## **BID ADDENDUM NO. 3**

### **Johnson Student Center**

### **Building Demolition, Increment 1 (Demolition) and Increment 2**

RANCHO SANTIAGO COMMUNITY COLLEGE DISTRICT  
SANTA ANA, CA

**EXTERIOR ELEVATIONS - GENERAL NOTES**

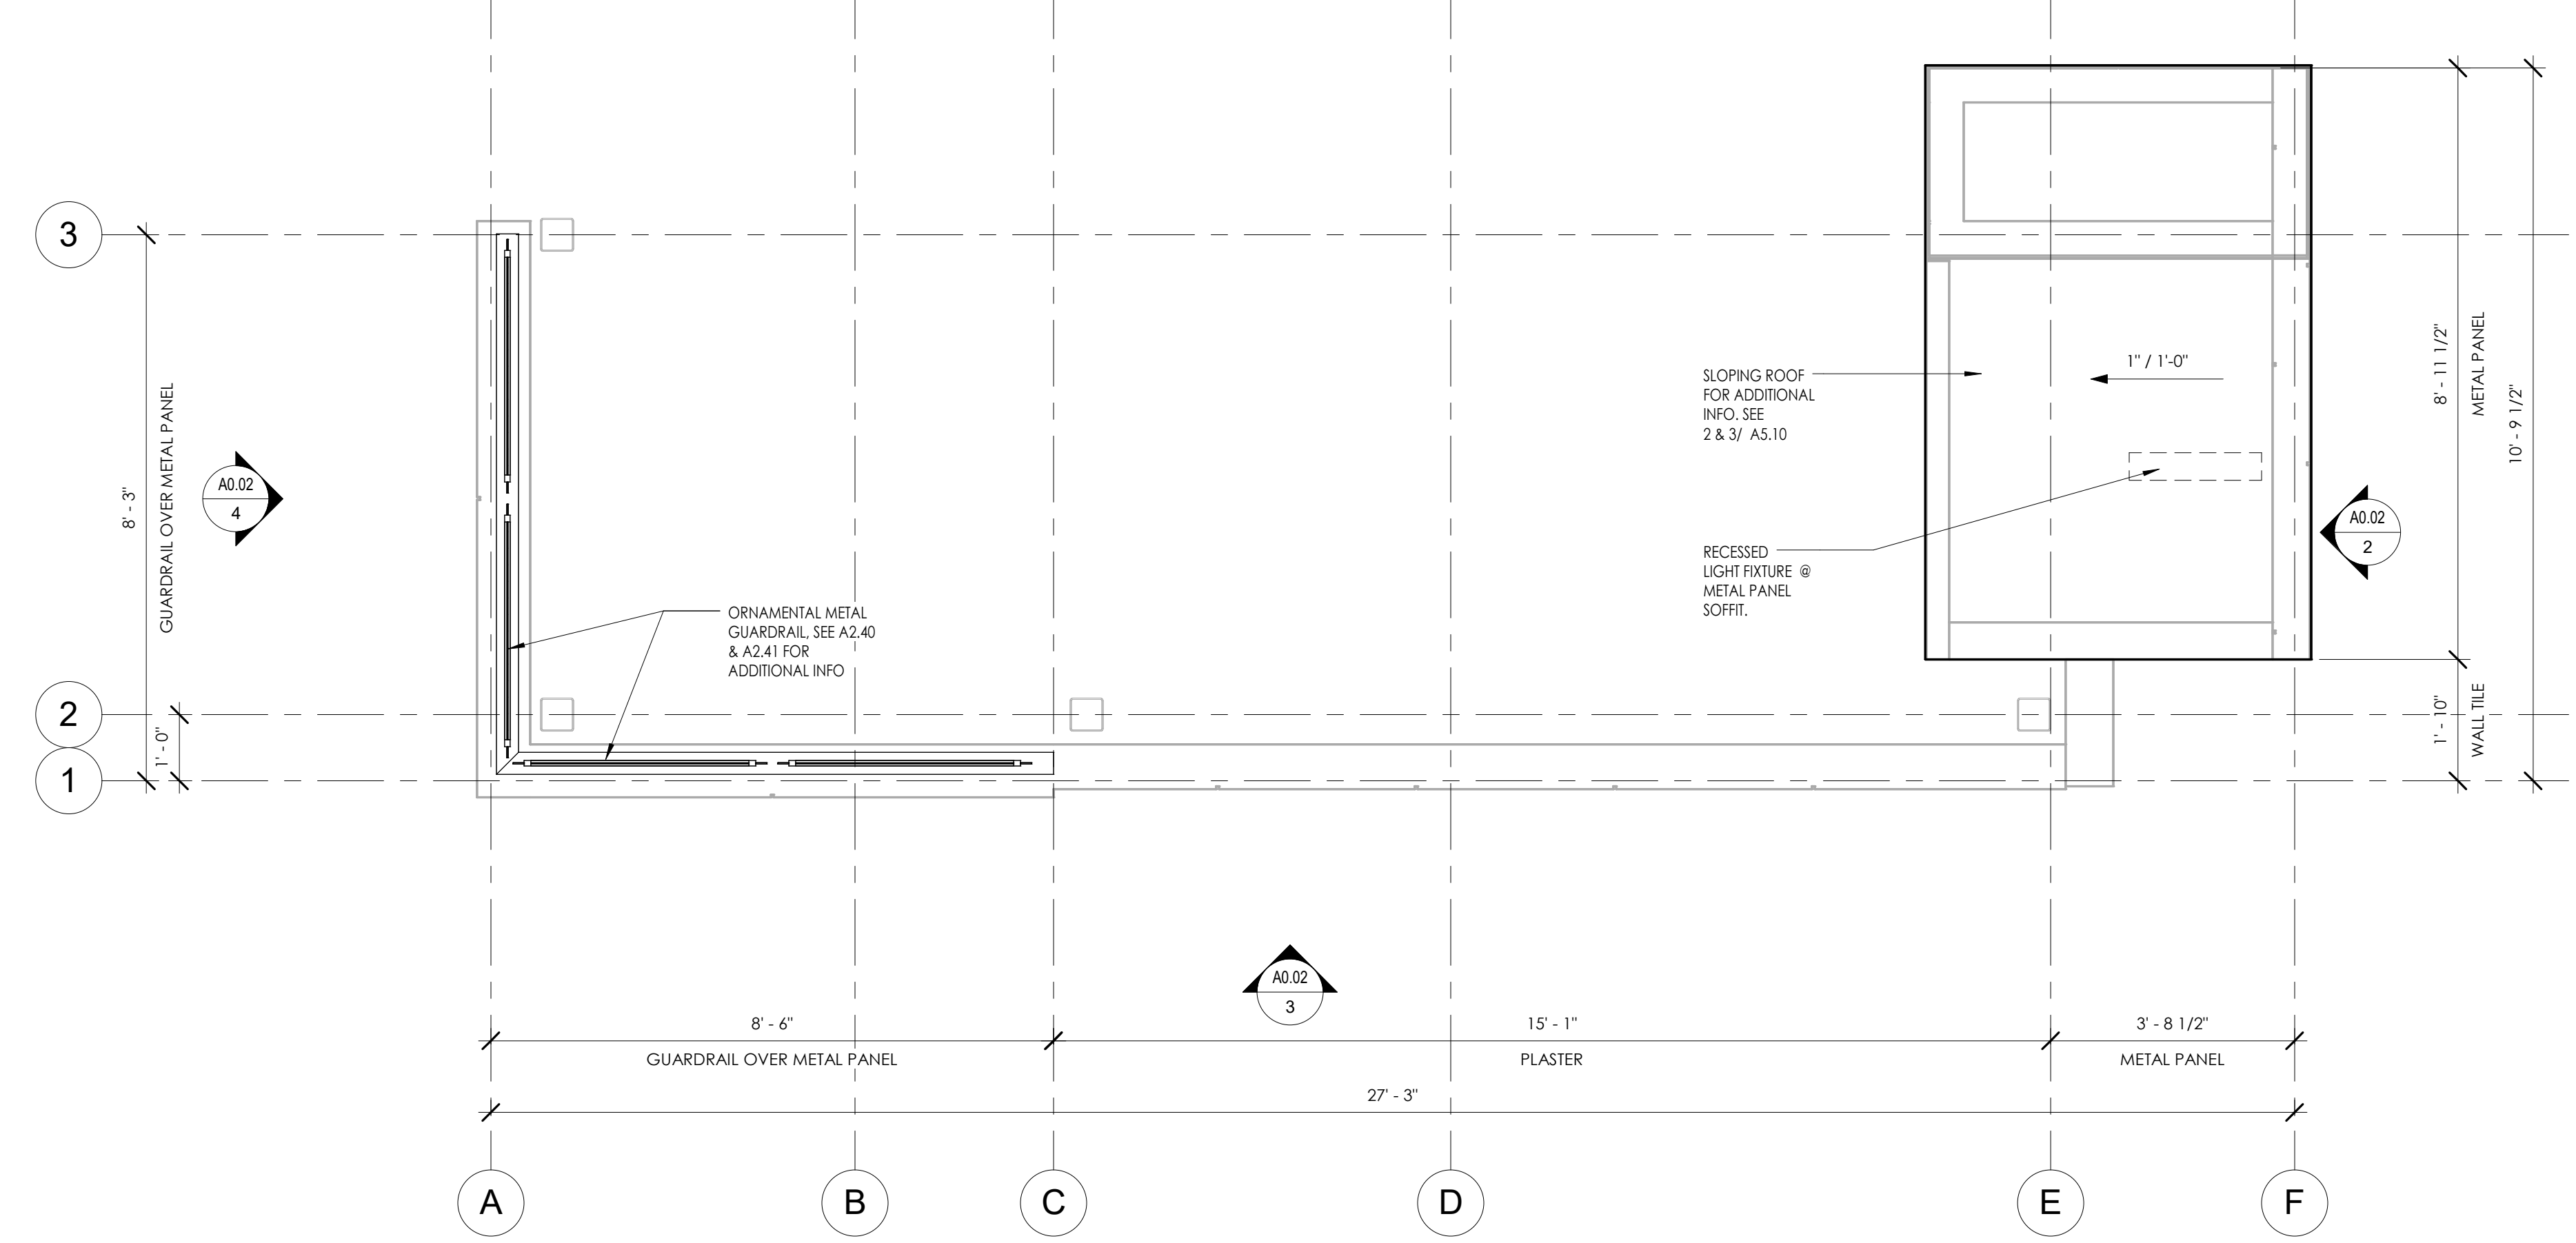
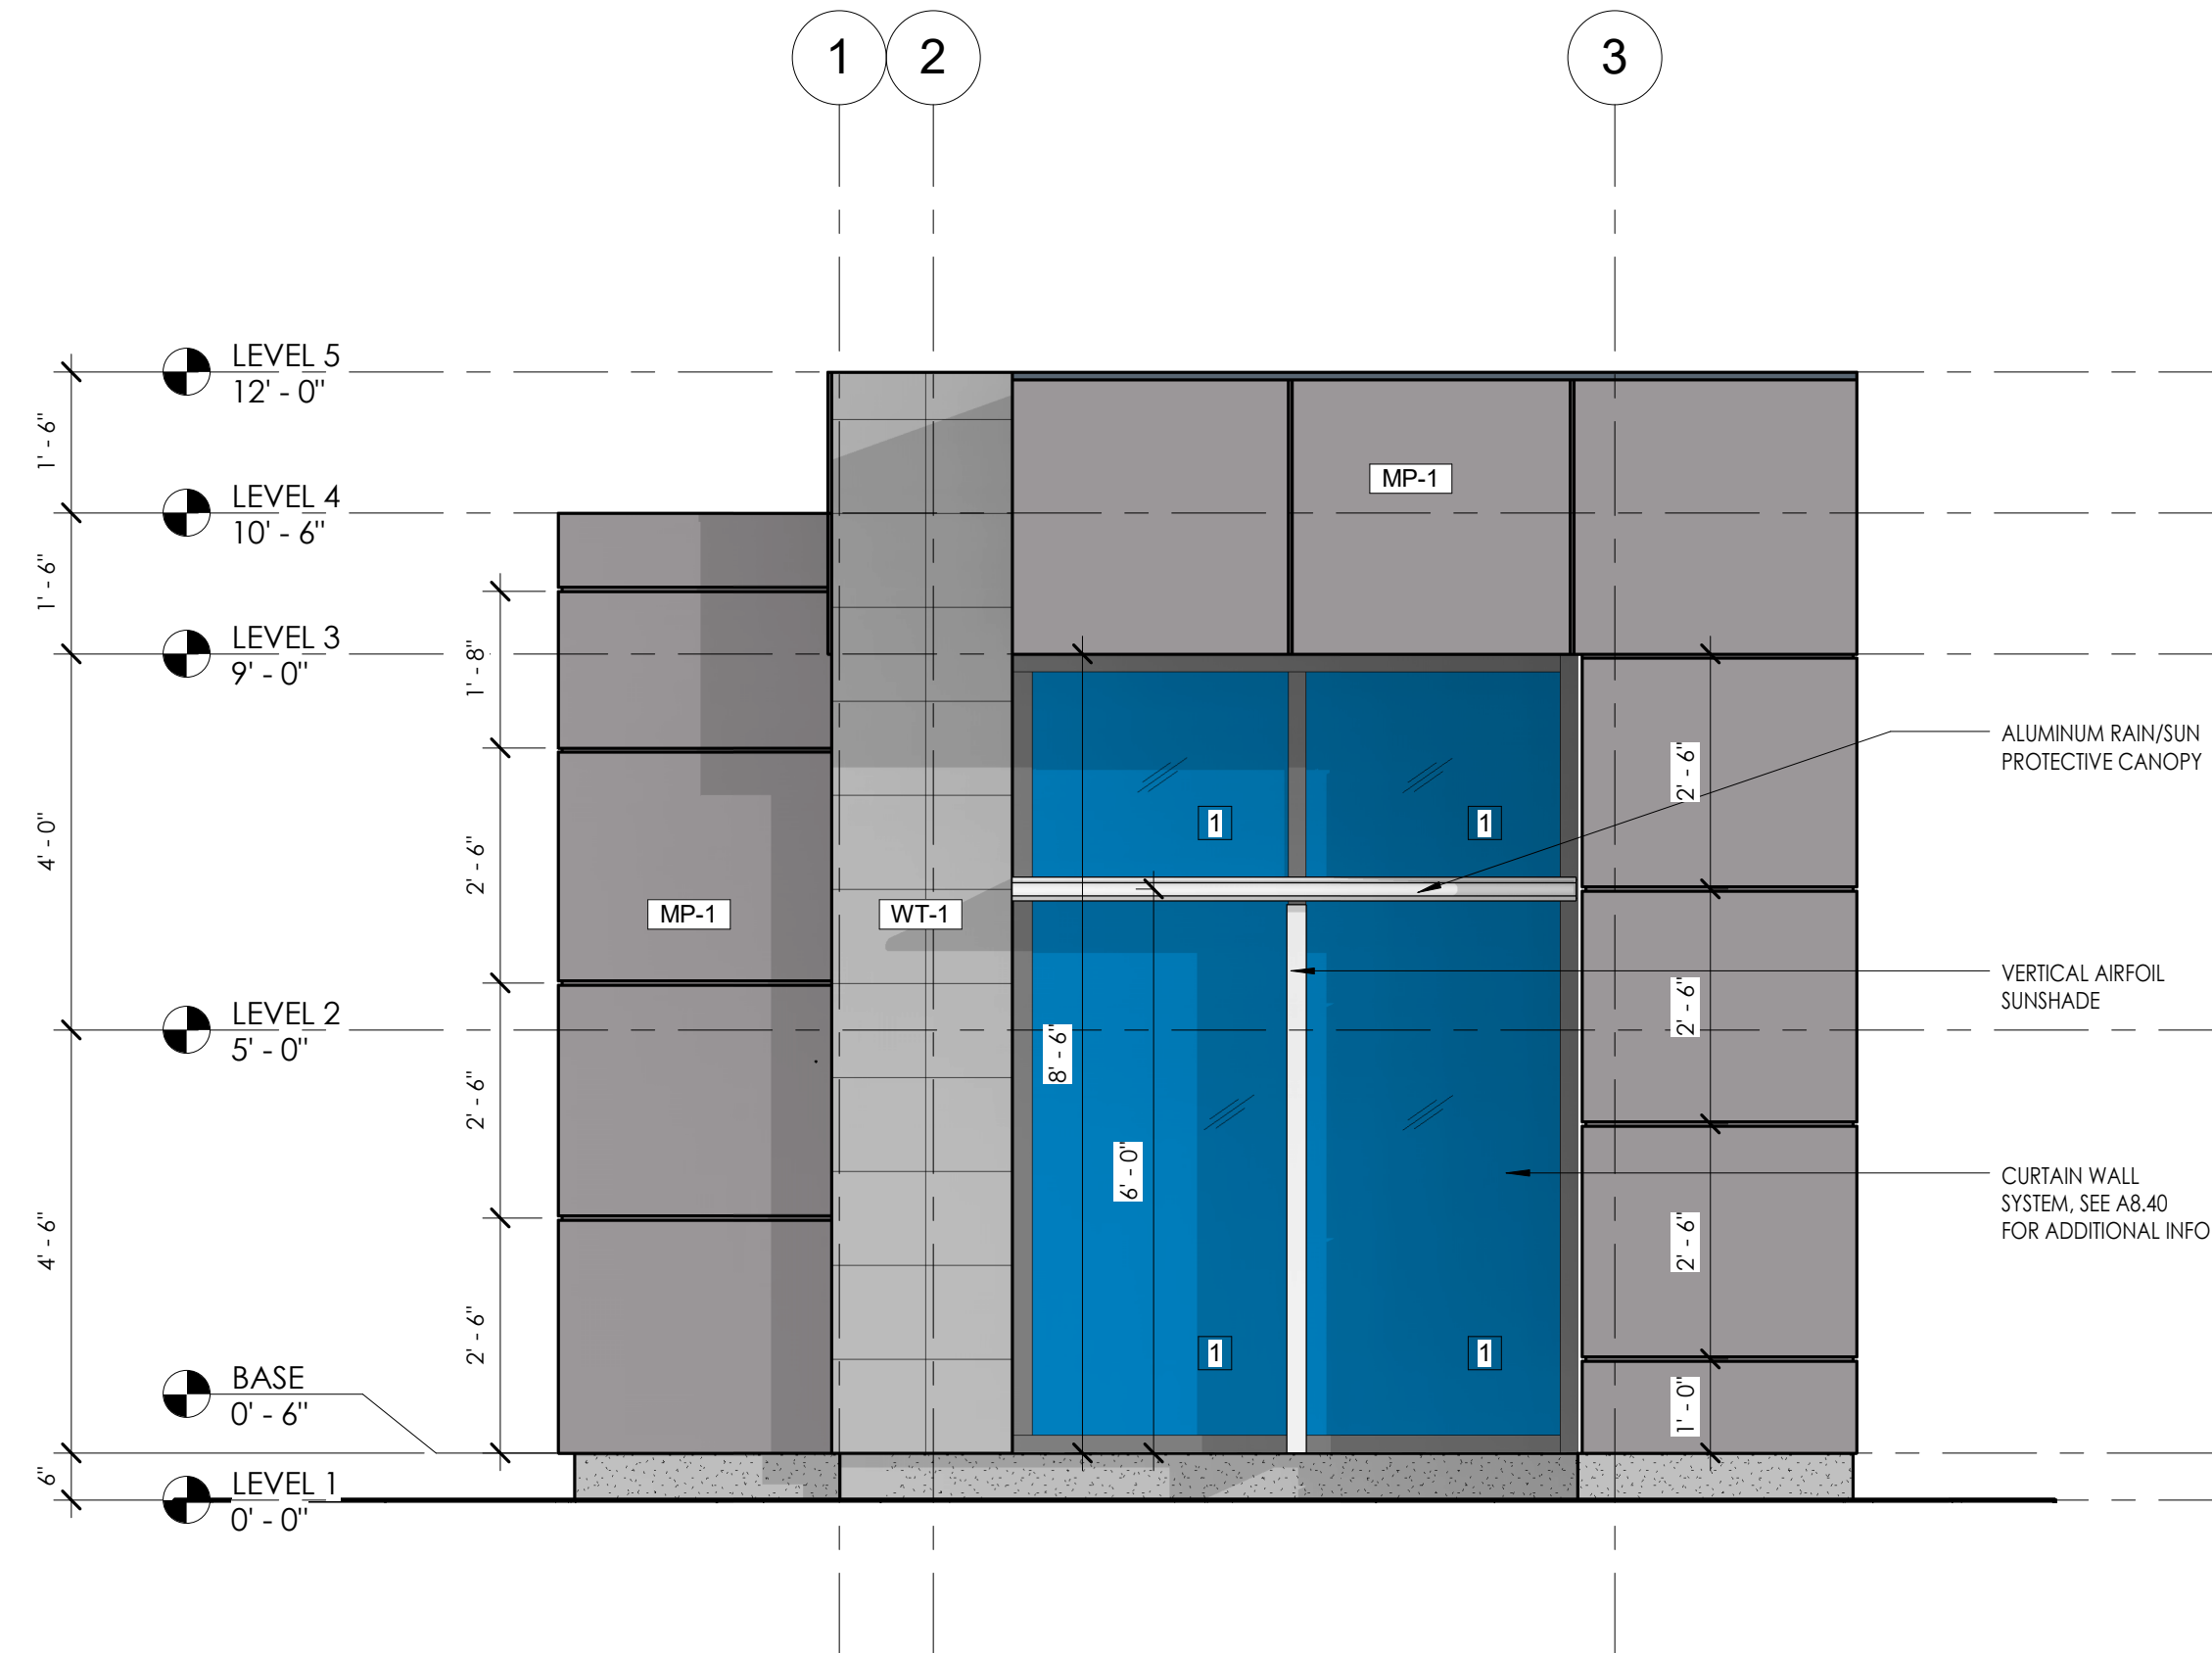
- Increment 2
  - i. General Contractor to provide an Exterior Material Mock-Up, refer to design drawings. Reference new sheets A0.01 and A0.02
- Increment 2
  - i. Added new detail sheet G3.12 (signage details) for monument / site signs.

1. SHEET METAL - SHOP FAB. IS ACCEPTABLE
2. SHEET METAL - TOUCH-UP PAINT REQUIRED FOR MOCKUP
3. CONTRACTOR TO COORDINATE LOCATION OF MOCKUP ON SITE
4. MOCKUP TO BE WORKING MOCKUP AND REVISIONS WILL BE MADE DURING CONSTRUCTION AS NEEDED PER ARCHITECT'S DIRECTION.
5. REFERENCE ISA APPROVED DRAWINGS AND SPECS (A194-11&10) FOR DETAILS AND MATERIAL C.
6. NO STRUCTURAL STEEL. MOCKUP IS INTENDED TO BE FRAMED WITH STEEL STUDS AND IS SELF-SUPPORTING.
7. MOCKUP SHALL BE FRAMED WITH 1 1/2" GA. 6" STUDS @ 12" O.C. U.N.O. REF TO SHEET SA.10 FOR MORE INFO.
8. DETAIL REFERENCES ARE INTENDED TO SHOW MATERIAL TRANSITION AND ASSEMBLY REFER TO SHEET A0.01 & A0.02 FOR DIMENSIONS.
